MONTGOMERY COUNTY HISTORIC PRESERVATION COMMISSION STAFF REPORT

Address: 7109 Cedar Ave., Takoma Park Meeting Date: 2/12/2020

Case Number: 37/03-20J

PROPOSAL: Window replacement and new window installation

Fig. 2: 1927 Sanborn Fire Insurance Map, with subject property circled in red.

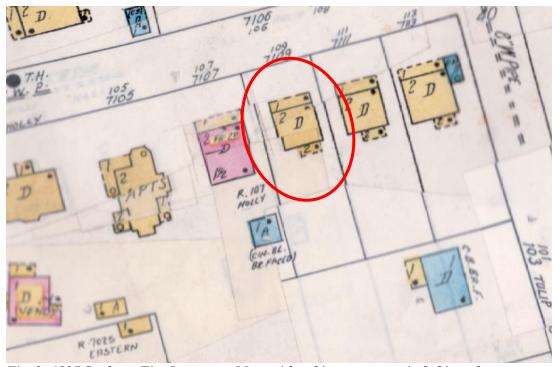
The proposed new second-floor window on the east (rear) elevation will also be a horizontally oriented aluminum-clad rectangular awning window. The proposed new window will not be visible at all from the public right-of-way, and, in accordance with the *Guidelines*, should be approved as a matter of course. Staff also notes that the 1927 Sanborn Fire Insurance Map depicts a two-story open porch at the rear of the house, and there may have previously been a door opening in the approximate location of the proposed new window (see Fig. 2 below).

FRONT VIEW OF HOME

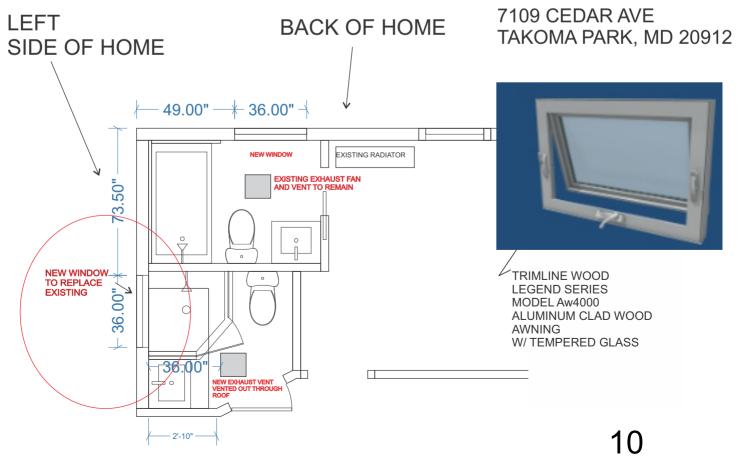
The second-floor window to be replaced on the northeast (left) elevation is non-original and is located near the rear/left corner of the house. The existing window is only be visible when viewing the house from an oblique angle within the public right-of-way of Cedar Avenue.

The existing window is a vertically oriented rectangular fixed window, while the proposed new window will be a horizontally oriented aluminum-clad rectangular awning window. Staff finds that, because the window to be altered is not original to the house, the proposed window replacement is consistent with the *Guidelines* regarding window openings.
